ANN ARBOR HISTORIC DISTRICT COMMISSION

Staff Report

ADDRESS: 406-408 S. Seventh Street, Application Number HDC20-067

APPLICATION: The applicant seeks HDC approval to expand the footprint of the rear wing of the house slightly, remove a modern second-floor addition, and construct a new second-floor on the rear wing with side-facing gables.

South Elevations

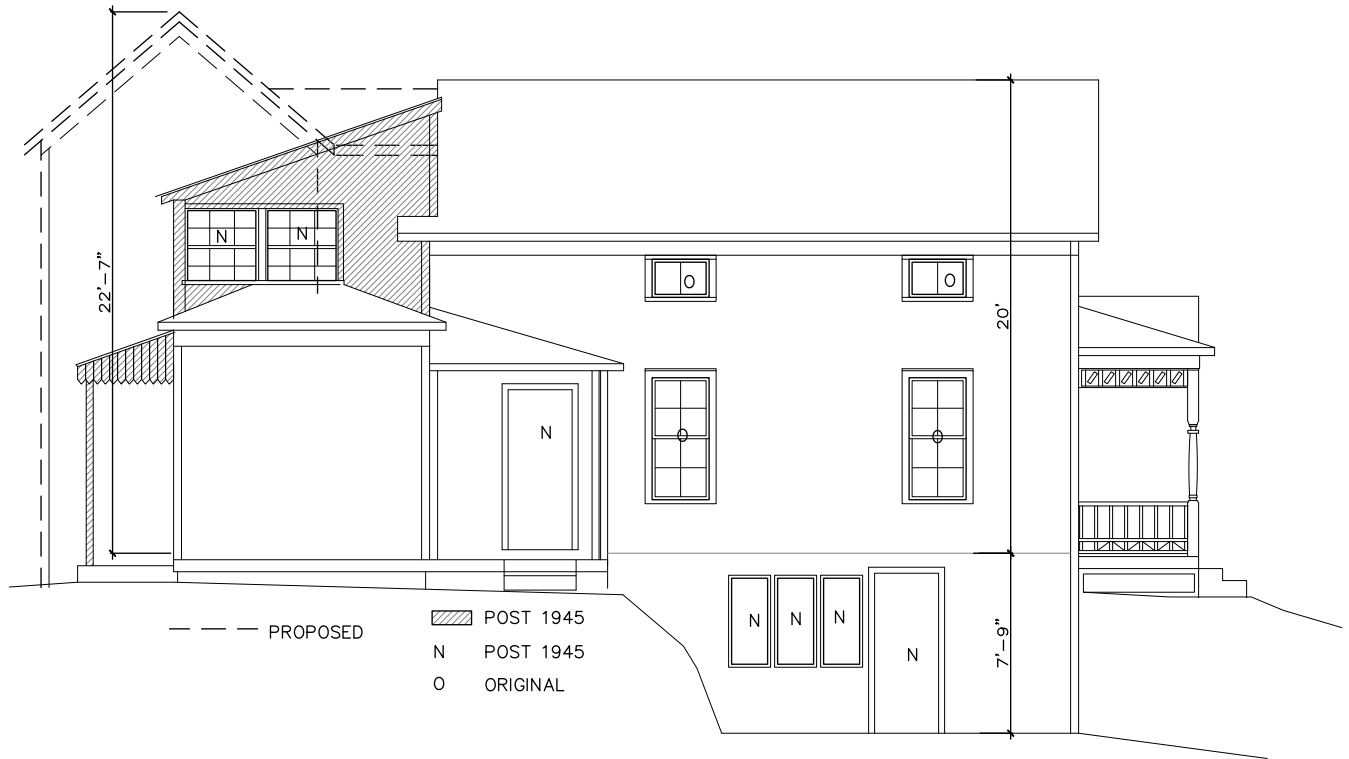
4. The roof of the new rear second floor has a ridge that is 2’7” taller than the ridge of the main house block. While this is usually not appropriate, exceptions are made occasionally. The proposed addition would be visible from both the south and north. The existing shed-roof second floor is also visible, and is extremely incompatible. On the south, the new gable will be slightly offset from the main house block. Keeping the existing side porch and single story bump-out room makes the change less radical. On the north, the new gable is separated from the main house block by several feet due to a small existing courtyard. From past experience staff prefers a slightly taller gable that more closely matches the pitch of the existing gables than a flattened one that is lower but sacrifices compatibility.
